District of Columbia Government  
Advisory Neighborhood Commission 6A  
Box 75115  
Washington, DC 20013

Re: Midblock Traffic Signal on Maryland Avenue between 9<sup>th</sup> and 10<sup>th</sup> Streets, NE

#### Exhibit A - Location Map

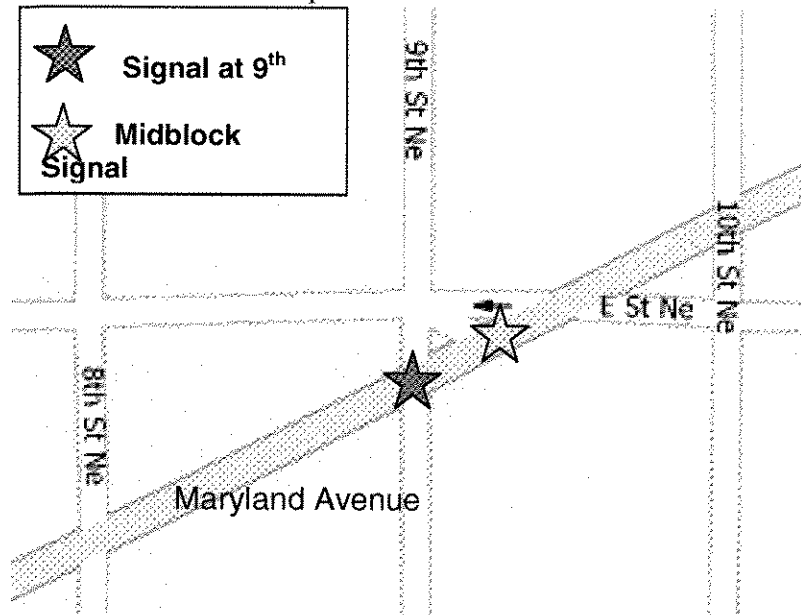
At our May 10, 2007, Commission meeting, we voted unanimously to request that the existing midblock traffic signal, located on Maryland Avenue, between 9<sup>th</sup> and 10<sup>th</sup> Streets NE be assessed by DDOT for improvements. There have been a number of reported observations of eastbound Maryland Avenue motorists running the red light located 9<sup>th</sup> Street by residents and ANC Commissioners. See exhibit A for an aerial graphic of the intersection.

The observations of the red light running occur when the motorists waiting at 9<sup>th</sup> (red signal) sees the midblock signal turn green (again, see exhibit A). A similar condition seems to exist for the other traffic movements in addition to this movement.

We are requesting that DDOT perform a field inspection of the existing signal timing and signal placement and report back to ANC 6A with a plan for improvements to this dangerous intersection. It appears this issue can be simply solved by removing the duplicative signals which are causing this confusion. To illustrate this point, if a motorist is turning right from 9<sup>th</sup> to Maryland, they don't need to see a signal to proceed straight. This signal should be removed. The signal facing the eastbound traffic (located on the same pole) for E Street traffic can remain and be phased for red which would be out of the view of the eastbound Maryland Avenue traffic.
